PERMANENT WTC PATH TERMINAL

FINAL ENVIRONMENTAL IMPACT STATEMENT

United States Department of Transportation
Federal Transit Administration

PATH-Lex Connection Basic Alignment (2.8)

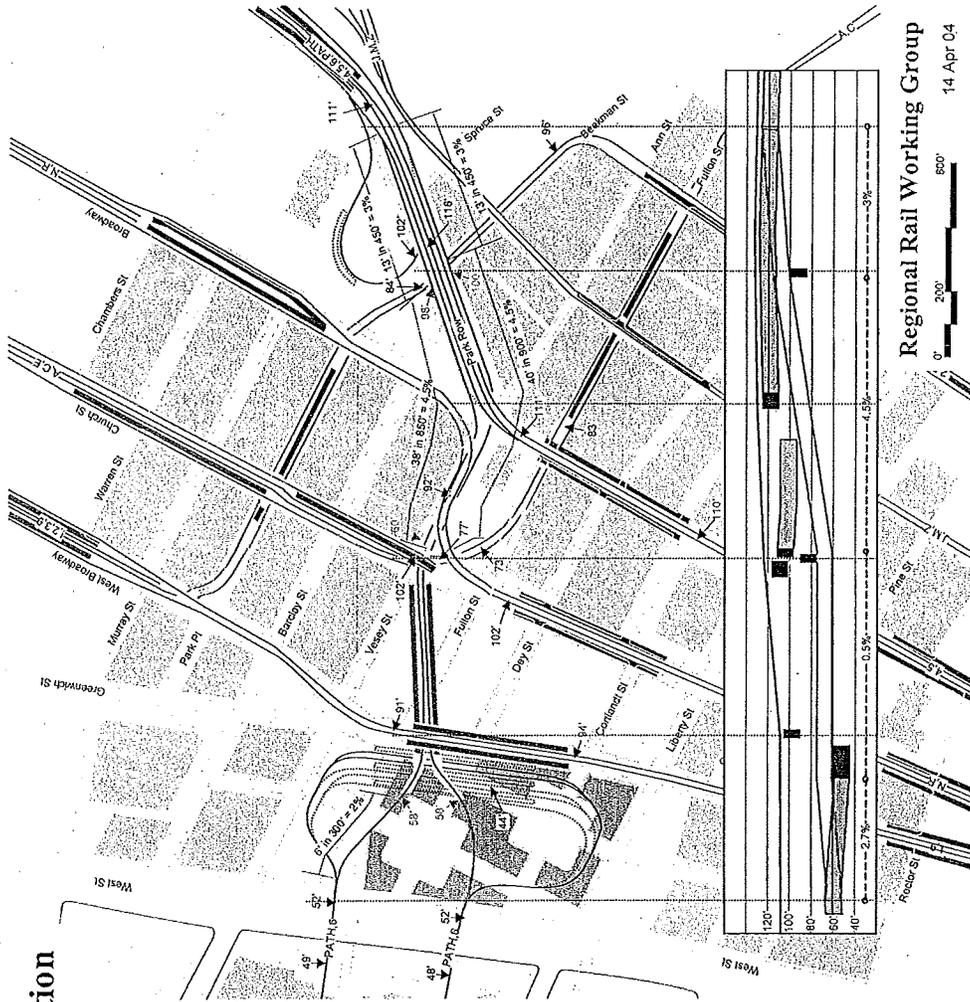
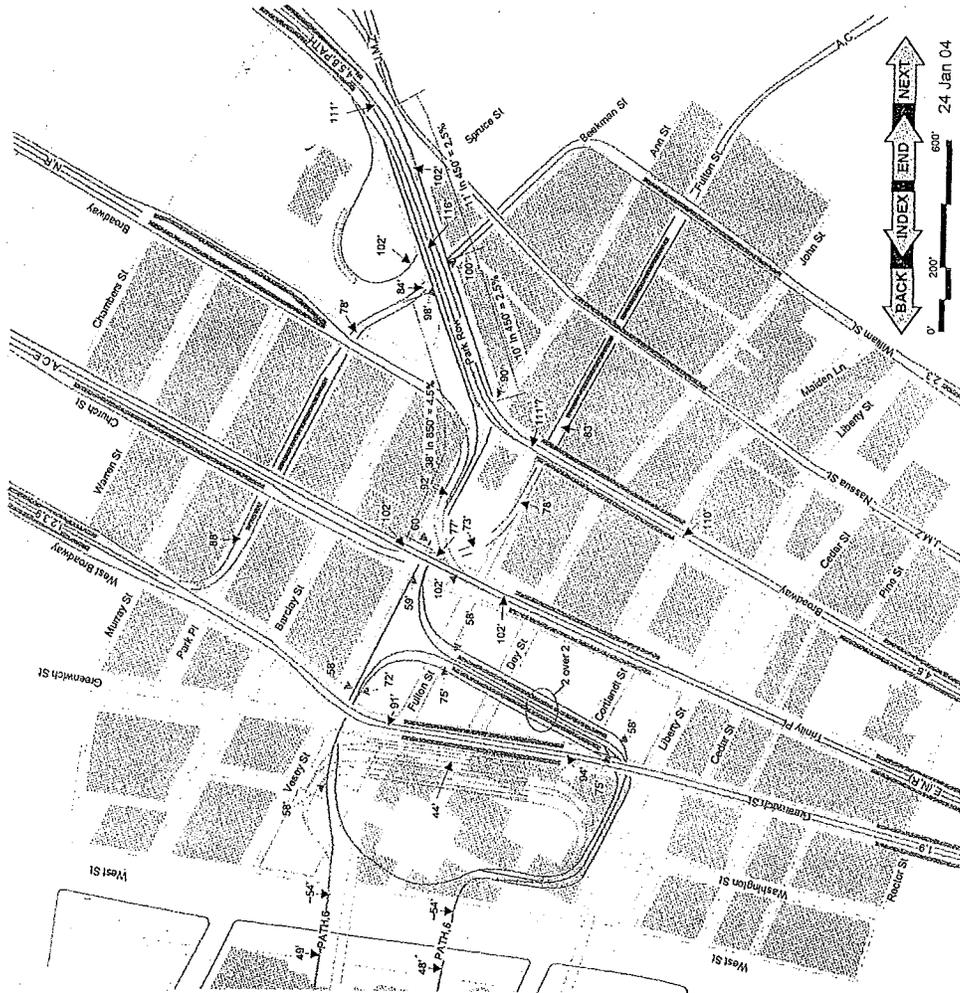
This alignment connects the PATH tracks at the west side of the World Trade Center cellar with the Lexington Avenue local tracks just south of the Brooklyn Bridge - City Hall station. The new tracks rise from the PATH tunnel portals, pass over the tracks and platforms of the temporary PATH station, under the 1 & 9 in Greenwich Street, under the A & C at Church and Vesey Streets, the northbound track passes under the 4 & 5 at Broadway and Park Row, the tracks then rise on either side of the 4 & 5, pass over the 2 & 3 at Beekman Street, sever the loop used by the 6 at City Hall and connect to the local tracks just south of the station.

The new PATH-Lex station allows service from New Jersey to be split. Trains using the west side of the station return to New Jersey, trains using the east side continue north on the Lexington Avenue line. Trains from Manhattan loop around the north tower footprint and use the west side of the station before continuing to New Jersey or the east side before returning north. (For clarity the platforms are shown next to each other, however they are stacked.)

East of Church Street the track alignment is shown along Park Row, which severs the City Hall loop. Alternatives include an alignment through City Hall Park and one split between the park and Park Row.

This sketch also shows an extension of the IND (E) connecting to the BMT south of Fulton Street.
